**SERVICE BULLETIN**  
**REVISION TRANSMITTAL SHEET**

NACELLES/PYLONS - Attach Fittings - Lubricate/Replace Engines 1 and 3 Forward Attach Spherical Bearings.

This page transmits Revision 3 for DC-10 Service Bulletin 54-59 to incorporate the following changes:

Bulletin 54-59

FIGURE 1 (SHEET 1 OF 3)

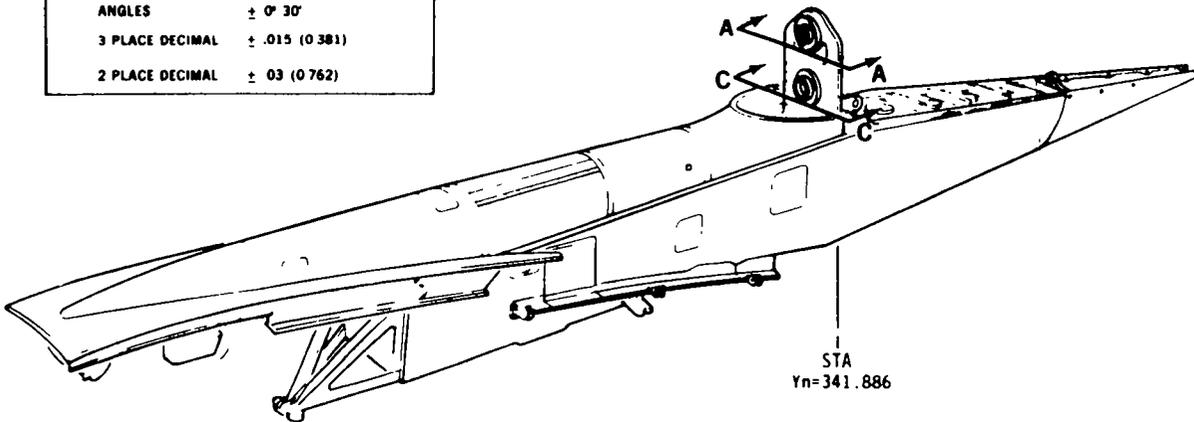
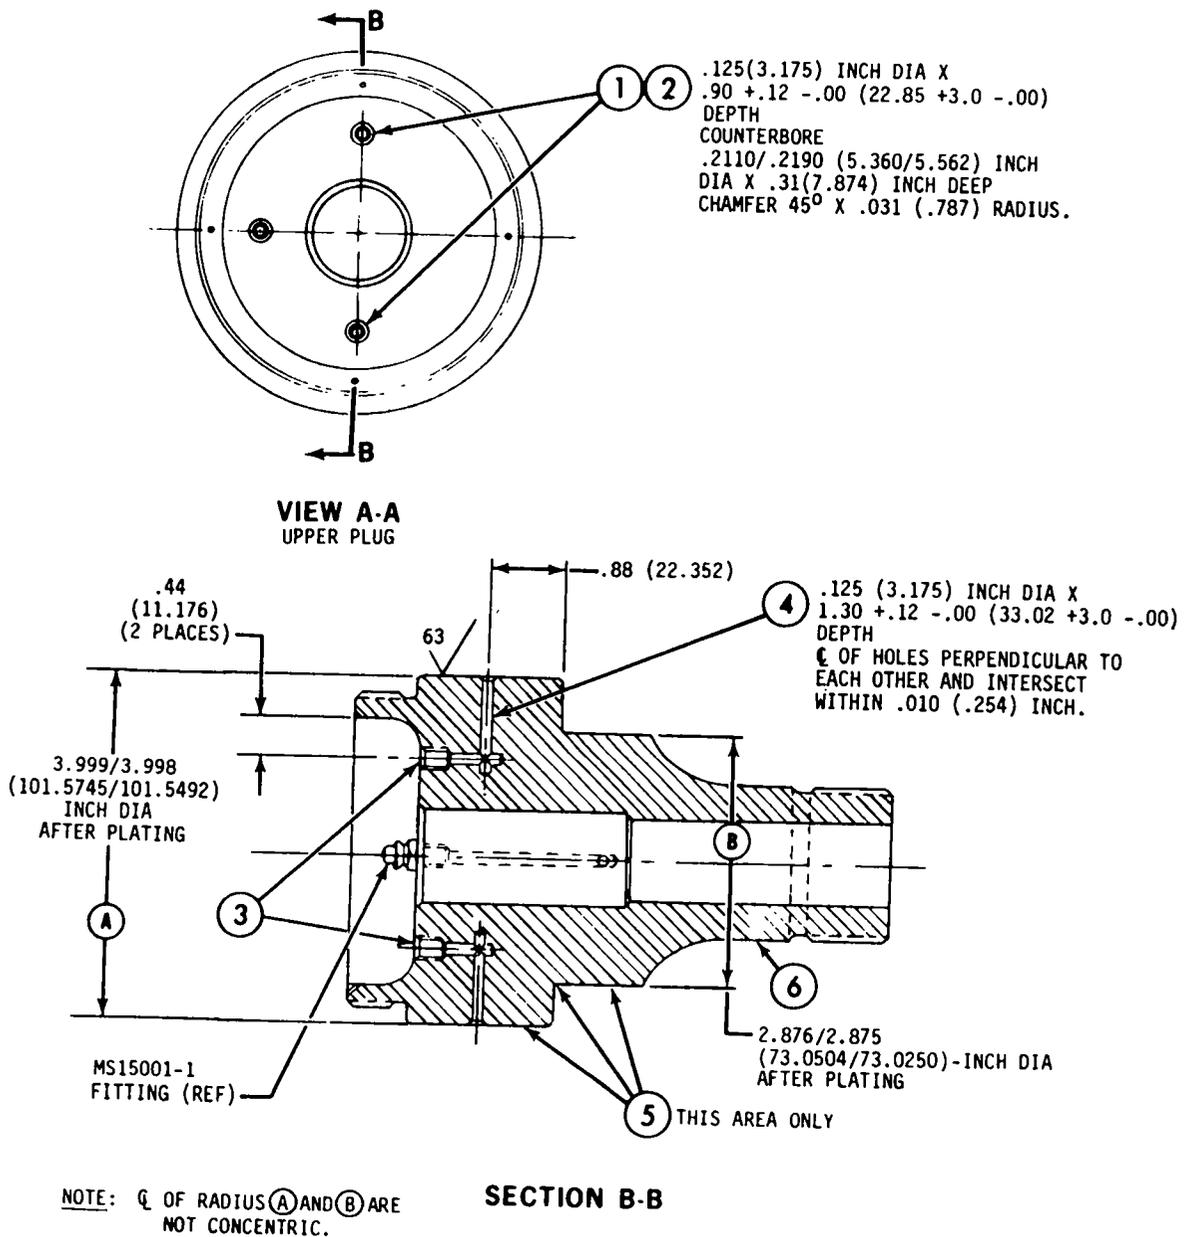
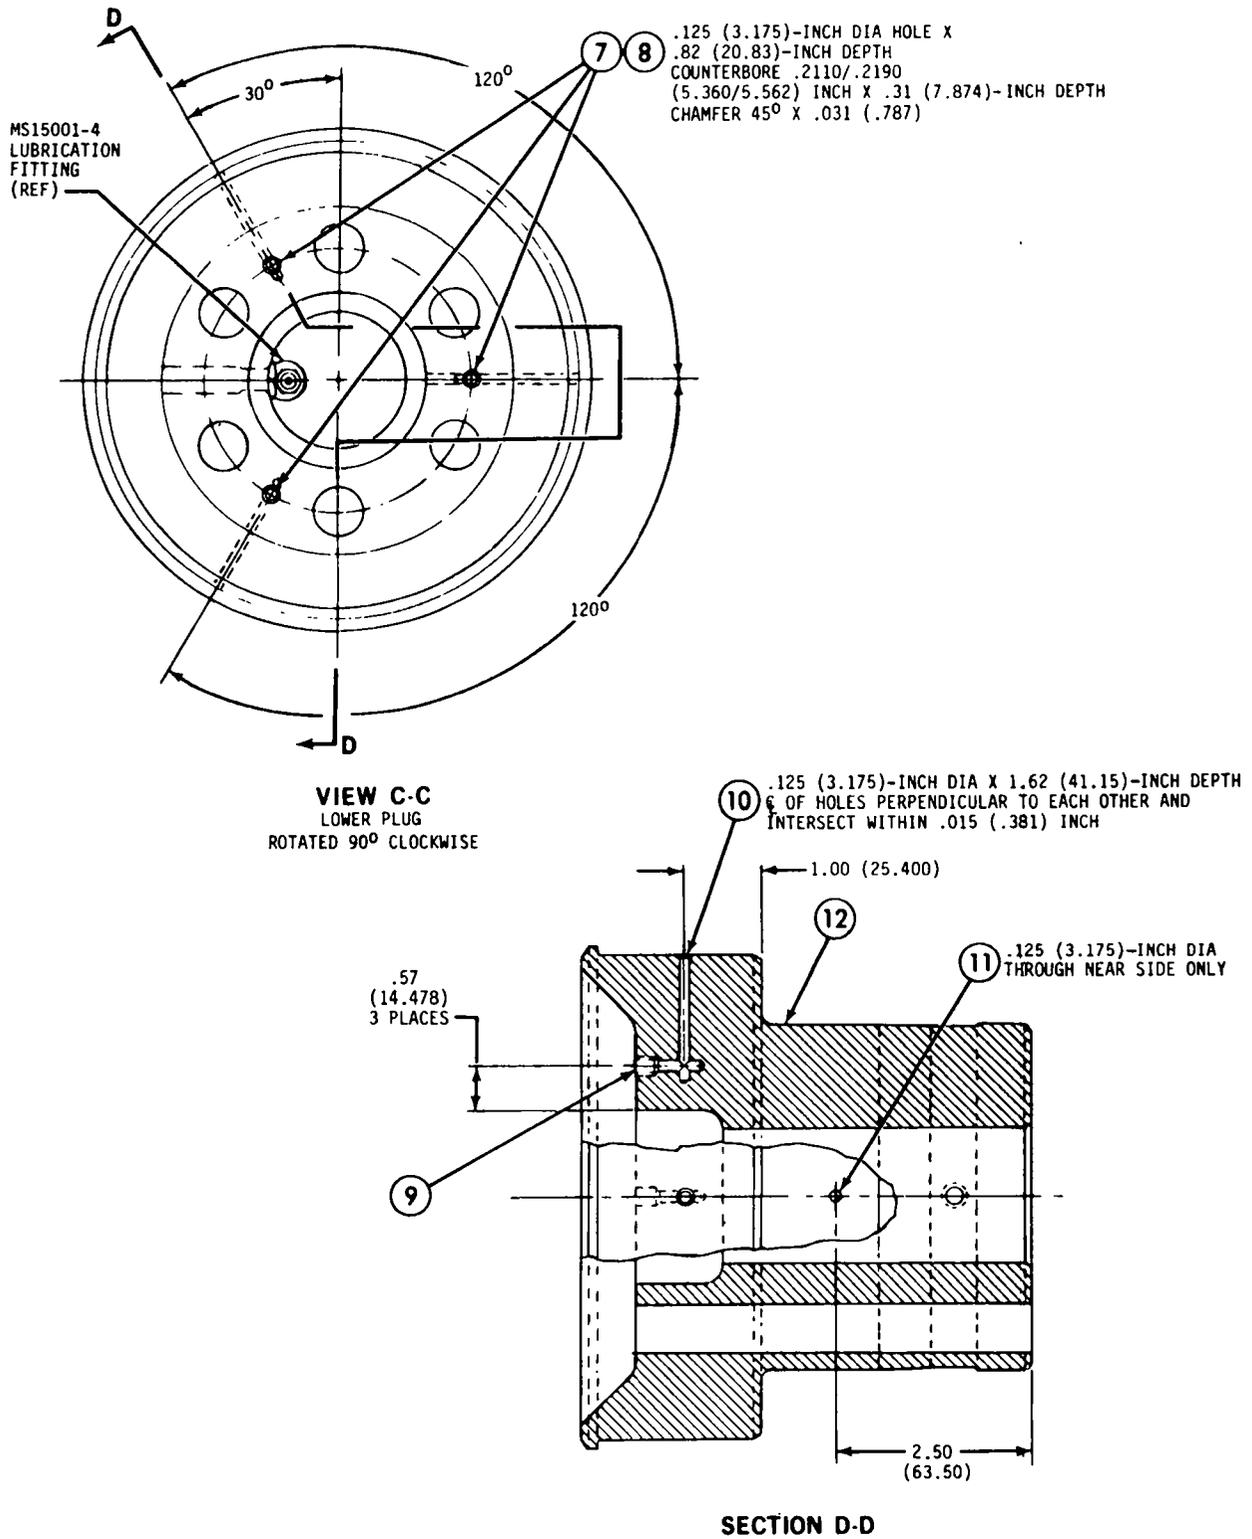
- B. Remove upper spherical bearing, retain attaching parts.
- C. Modify upper wing-to-pylon attach plug as shown on Figure 1.
- D. Install new 79748, HSPF-64-MD, KSB64-3, AMB64-100, or ASSB64 spherical bearing using retained attaching parts.

- G. Remove lower spherical bearing. Retain attaching parts.
- H. Modify lower wing-to-pylon attach plug as shown on Figure 1.
- I. Install new 79749, HSPF-100-MD, KSB100-3, AMB100-100, or ASSB100 spherical bearing using retained attaching parts.

- ① DRILL TWO HOLES IN UPPER WING-TO-PYLON ATTACH PLUG.
- ② THREAD COUNTERBORED HOLES 1/4-28UNF-3B, PERFECT THREAD .19 (4.82)-INCH MINIMUM DEPTH.
- ③ INSTALL TWO MS15001-1 LUBRICATION FITTINGS.

- ④ DRILL TWO HOLES TO INTERSECT HOLES DRILLED IN STEP 1.
- ⑤ AUB7065-503 PLUG ONLY - MODIFY PLUG ASSEMBLY AS OUTLINED IN DC-10 STRUCTURAL REPAIR MANUAL, CHAPTER 54-20-00, PARAGRAPH ENTITLED, "REWORK PROCEDURES FOR AUB7065-503 PLUG."

- ⑥ REIDENTIFY MODIFIED AUB7065-503 UPPER PYLON-TO-WING ATTACH PLUG AS AUB7065-505 PER OPERATOR'S SHOP PRACTICE. REIDENTIFICATION OF MODIFIED AUB7065-1 OR -501 PLUG IS AT OPERATOR'S OPTION.

- ⑦ DRILL THREE HOLES IN LOWER WING-TO-PYLON ATTACH PLUG.
- ⑧ THREAD COUNTERBORED HOLES 1/4-28UNF-3B, PERFECT THREAD .19 (4.82)-INCH MINIMUM DEPTH.
- ⑨ INSTALL THREE MS15001-1 LUBRICATION FITTINGS.

- ⑩ DRILL THREE HOLES TO INTERSECT HOLES DRILLED IN STEP 7.
- ⑪ DRILL ONE .125 (3.18)-INCH DIAMETER HOLE THROUGH NEAR SIDE (SIDE OPPOSITE EXISTING LUBRICATION FITTING) WALL OF LOWER WING-TO-PYLON ATTACH PLUG.

- ⑫ REIDENTIFY AUB7066-1 LOWER WING-TO-PYLON ATTACH PLUG AS AUB7066-501 PER OPERATOR'S SHOP PRACTICE.

FIGURE 2

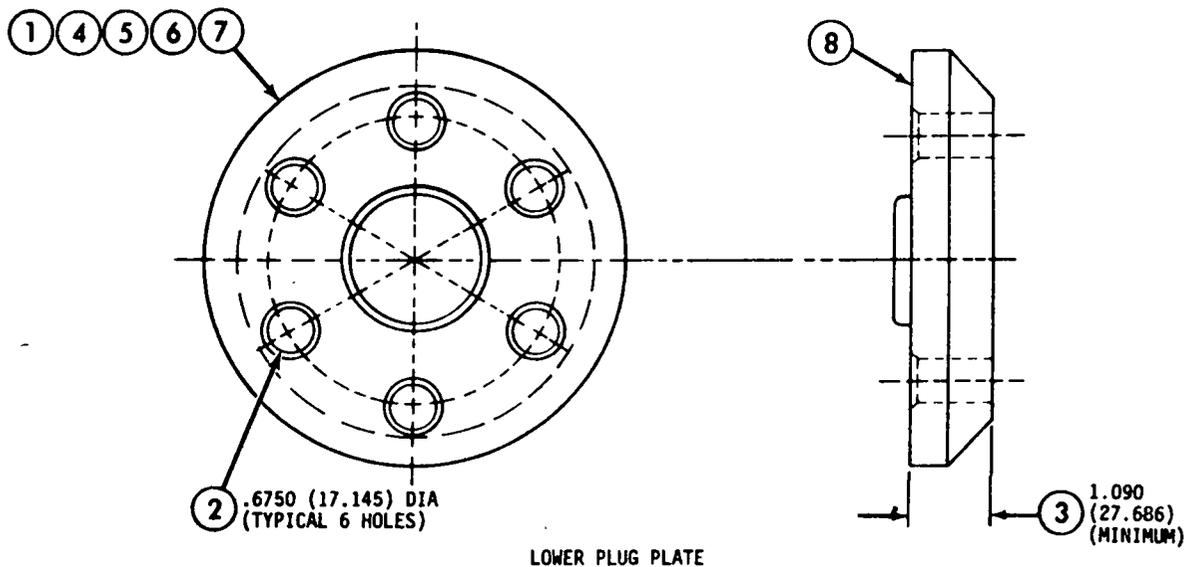
- M. Check lower plug plate for corrosion. See Figure 2.
- N. Install lower spherical bearing, attach plug, and lower plug plate using retained attaching parts. Coat retained bolts using 90-006 sealant with 90-006-2 catalyst. Prime using DC1200 silicone primer. Use six new 62524-9-24.9 PLI washers on installation.

- J. Check lower plug plate for corrosion. See Figure 2.
- K. Install lower wing-to-pylon attach plug and lower plug plate using retained attaching parts. Coat retained bolts using 90-006 sealant with 90-006-2 catalyst. Prime using DC1200 primer. Use six new 62524-9-24.9 PLI washers on installation.

- ① CHECK LOWER PLUG PLATE FOR CORROSION. IF CORROSION IS EVIDENT, REMOVE CORROSION PER DC-10 STRUCTURAL REPAIR MANUAL, CHAPTER 51-21-01, VOLUME II, AND PROCEED TO STEP 2. IF NO CORROSION EXISTS, PROCEED TO STEP 7.

- ② MAXIMUM HOLE DIAMETER AFTER REMOVAL OF CORROSION IS .6750(17.145) INCH DIAMETER.
- ③ MINIMUM THICKNESS AFTER REMOVAL OF CORROSION IS 1.090(27.686) INCH.

- ④ IF THE CORROSION HAS BEEN REMOVED BY LOCAL BLENDING OR MACHINING, RETURN REWORKED AREA TO A PLANE SURFACE BY SULFAMATE NICKEL PLATING PER DC-10 COMPONENT MAINTENANCE MANUAL, CHAPTER 20-10-02.

- ⑤ IF LOWER PLUG PLATE HAS BEEN MACHINED TO A FLAT BEARING SURFACE, SULFAMATE NICKEL PLATING IS NOT REQUIRED.
- ⑥ RESTORE CADMIUM PLATE FINISH PER DC-10 COMPONENT MAINTENANCE MANUAL, CHAPTER 20-10-01, AFTER ANY CORROSION REWORK.

- ⑦ APPLY A COAT OF FR EPOXY PRIMER TO SURFACE OF LOWER PLUG PLATE.
- ⑧ APPLY A COAT OF CORROSION PREVENTATIVE COMPOUND, MIL-C-16173 GRADE 4 (BRAYCOTE 194) OR EQUIVALENT, TO FACE OF LOWER PLUG PLATE.
